Emerson Process Management
Regulator Technologies, Inc.
3200 Emerson Way
McKinney, TX 75070

IMPORTANT PRODUCT SAFETY NOTICE

Brand: Fisher
Model: Type 627 regulators
Types: All type codes

November 1, 2019 through January 21, 2022

FIGURE 7 – Ductile iron (“DI”) casing marking

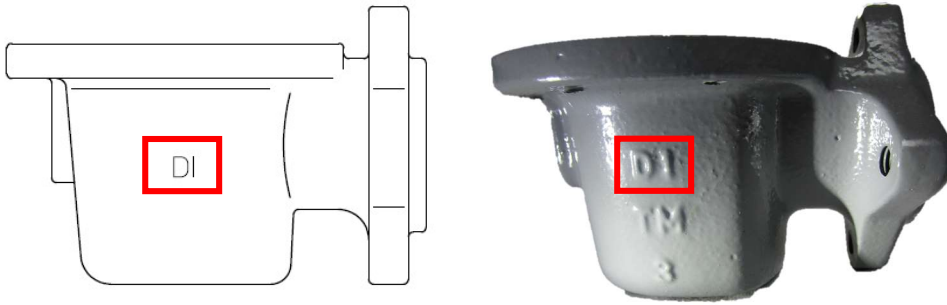
1. Locate the manufacturing date on the nameplate (Figure 6)
 - a. if in the affected range proceed to step 2
2. Identify the casing material
 - a. if ductile iron (Figure 7) or steel (Figure 8) proceed to step 3
3. Identify the body material and kit
 - a. if ductile iron (Figure 9) use bolt kit R627BOLTX12 which includes Grade 5 hex head bolts
 - b. if steel (Figure 10) use bolt kit R627BOLTX22 which includes stainless steel SHCS
 - c. Bolt kits include nitrile O-rings. If a different O-ring material is required, please contact your Emerson Impact Partner.

FIGURE 11 – Typical Type 627 Assemblies

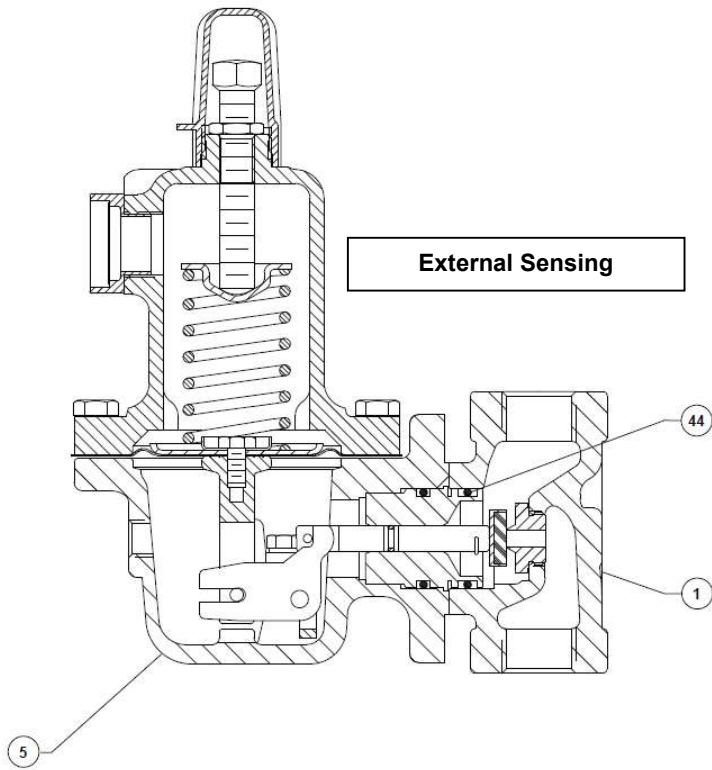
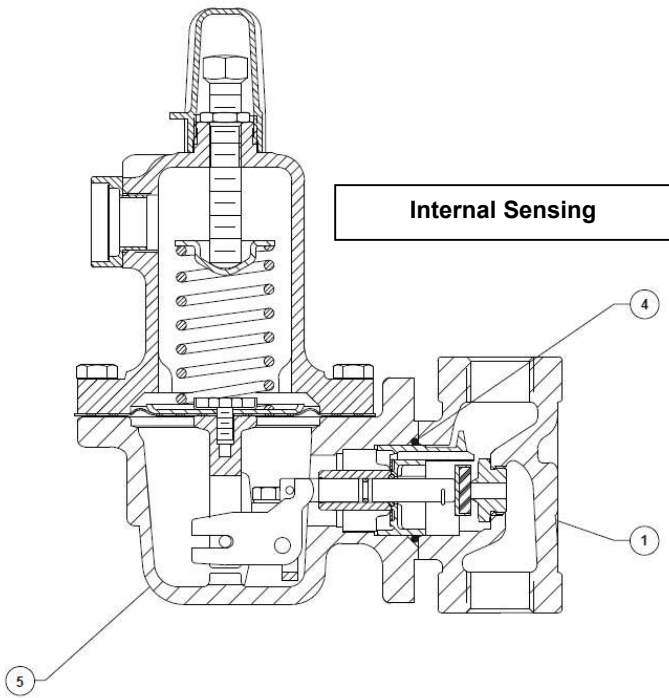
2. Remove the ASTM A574 SHCS body bolts (Figure 1, Key 3).
 - a. It is not required to remove the casing (Figure 11, Key 5) from the body (Figure 11, Key 1). If the casing is removed from the body, inspect the O-ring (Figure 11, Key 4 or 44) and replace if necessary.

1. Remove the ASTM A574 SHCS body bolts (Figure 1, Key 3).
 - a. It is not required to remove the casing (Figure 11, Key 5) from the body (Figure 11, Key 1). If the casing is removed from the body, inspect the O-ring (Figure 11, Key 4 or 44) and replace if necessary.

3. Reassemble with the applicable bolt based on body material:
 - a. Ductile iron - Grade 5 hex head bolts, P/N 1A341824052, from Kit R627BOLTX12
 - b. Steel - ASTM F837 SHCS, P/N ERAA49769A0 from Kit R627BOLTX22
4. Tighten the bolts evenly, alternately torquing until each reaches 25 ft·lbs.
5. Wire the provided identification tag to a body bolt in the exposed area between the body and casing, Figure 1.
6. Startup system and apply pressure:

2. Reassemble with the applicable bolt based on body material:
 - a. Ductile iron - Grade 5 hex head bolts, P/N 1A341824052, from Kit R627BOLTX12
 - b. Steel - ASTM F837 SHCS, P/N ERAA49769A0, from Kit R627BOLTX22
